## Planning, Land Use and Mobility Committee

### Case Report:

**New Single-Family Residence, street widening and replacement of the 12-foot-wide unimproved road with a 20 foot paved street, and 5-foot setbacks.**

**ZA-2021-8126-ZAD-ZAA; ENV-2021-8127-CE**

### **Site Development**

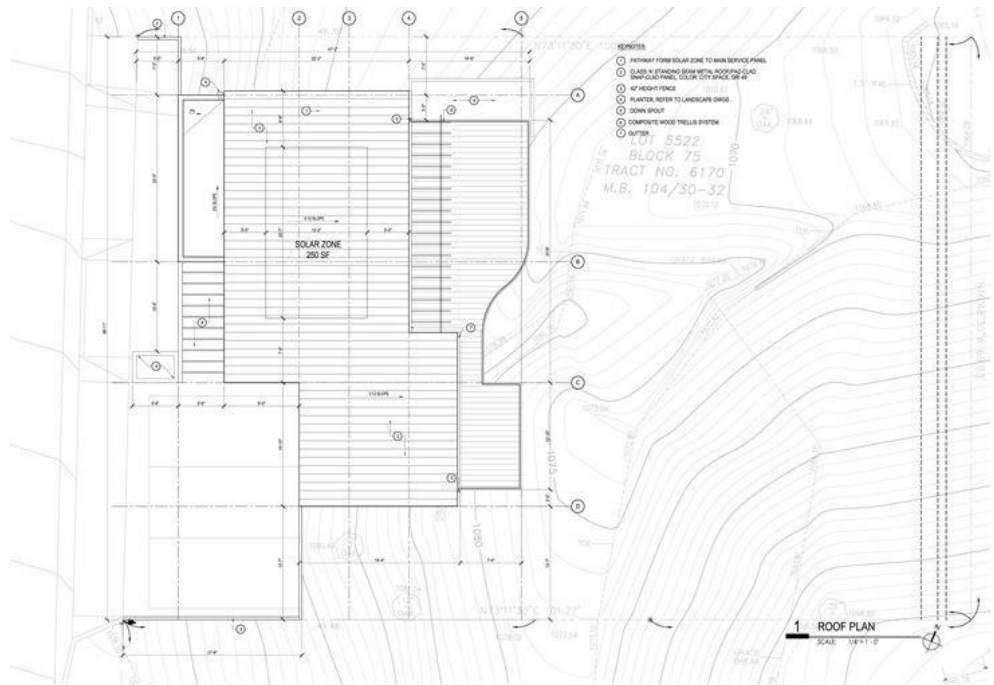
The project is construction of a new, three story, 2,795 square foot single family residence and attached 451 sq. ft. two car enclosed garage. The site will also accommodate 3 uncovered off street/onsite parking spaces. Development of this parcel will incur 130 cubic yards of cut and 130 cubic yards of fill, which is within the allowable grading amounts, as per the Mulholland Scenic Parkway Specific Plan. Four oak trees will be cut down, and sixteen new oak trees will be planted.

**Architectural Design and Materials**

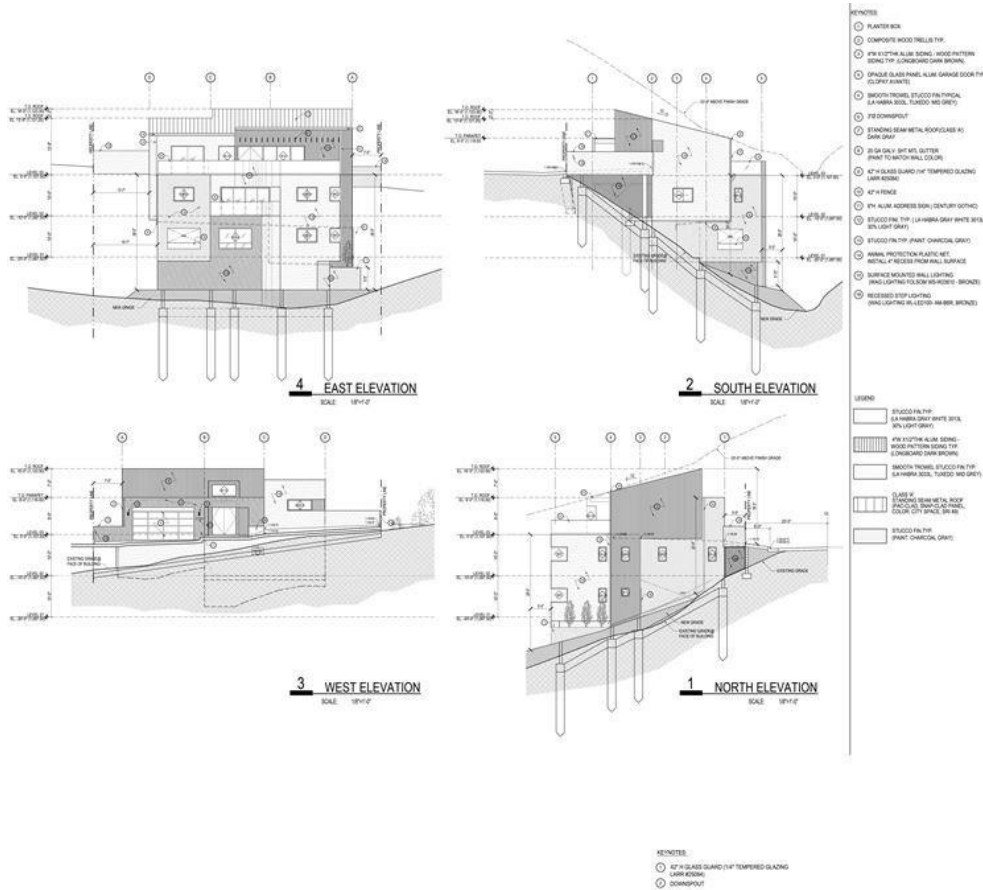
The residence is contemporary in massing and exterior materials. The structure mostly sits above the existing grade, with some vertical walls meeting grade and some vertical walls hovering above grade. From the side elevations, there are views where the building bridges and reveals the existing downhill slope. Most of the structure is enclosed by a standing seam metal shed style roof (class A fire rating), while part of the massing is enclosed by a flat roof / deck (at the backyard elevation). Building cladding includes smooth troweled stucco and vertical plank 1 x 4 hardwood siding. Railings at the East Elevation (Back yard) are glass and stucco. The garage door is frosted glass and aluminum.
